**Conservation Organizations'
Comments on the Supplemental Final EIS
for the NorthMet Project**

Submitted to the Minnesota Department of Natural Resources

December 21, 2015

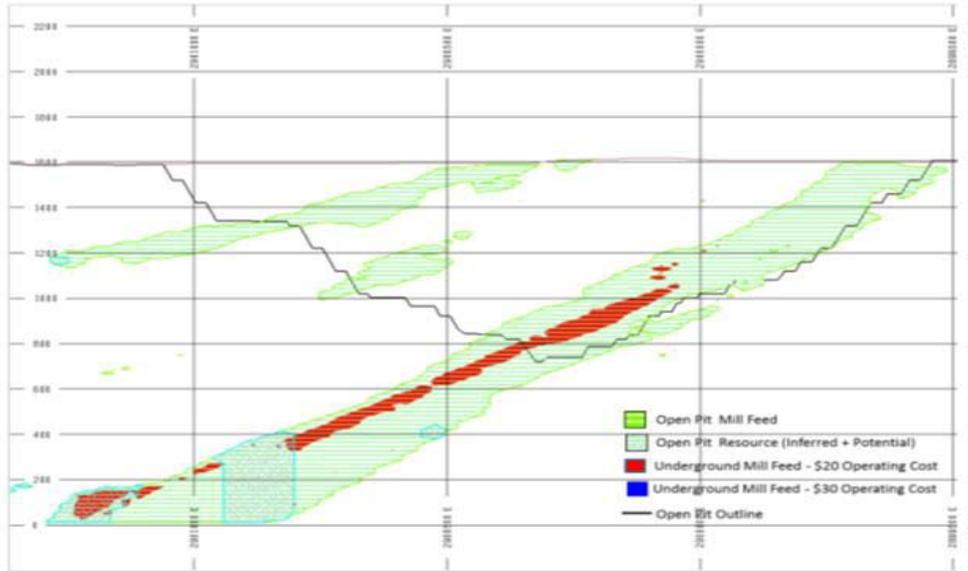
The existence of ore outside the pit envelope is a critical factor in determining whether an underground mine will be economical, because limitation to the pit envelope artificially limits the amount of ore of a particular grade that is available for mining. Co-Lead Report Table 2 provides net metal value for the five mining scenarios. Dividing this number by the total tons to be mined provides a value per ton. This exercise reveals that at the lower production rates, the minerals to be extracted have a higher per-ton value. The range is from \$60.40 per ton for the 5 million ton scenario to \$41.42 per ton for the 100 million ton scenario. These values are apparently based on how much ore there is in the pit envelope for each of the net metal values. That is, there are 5 million tons of mineable ore within the pit envelope with an average metal content worth \$60.40 per ton; 30 million tons with an average metal content worth \$51.73 per ton; and 50 million tons with an average metal content worth \$47.72 per ton.

Including mineralization beyond the pit envelope would affect the amount of ore available at each net-value-per-ton level. As an example, assume that the mine could be extended into an area that would provide 50 percent more ore of a given grade than is available within the pit envelope. The outcome would be that, for example, 30 million tons of ore would grade at \$53.85 per ton (the Co-Lead Report Table 2 net metal value per ton for 20 million tons of ore) rather than \$51.73 per ton. Mining costs might go up somewhat due to the increased area to be mined, but other costs would remain the same. This could add up to \$2.12 per ton in net value, or a total of \$60 million to the mine's profit in the 7500 tons-per-year scenario.
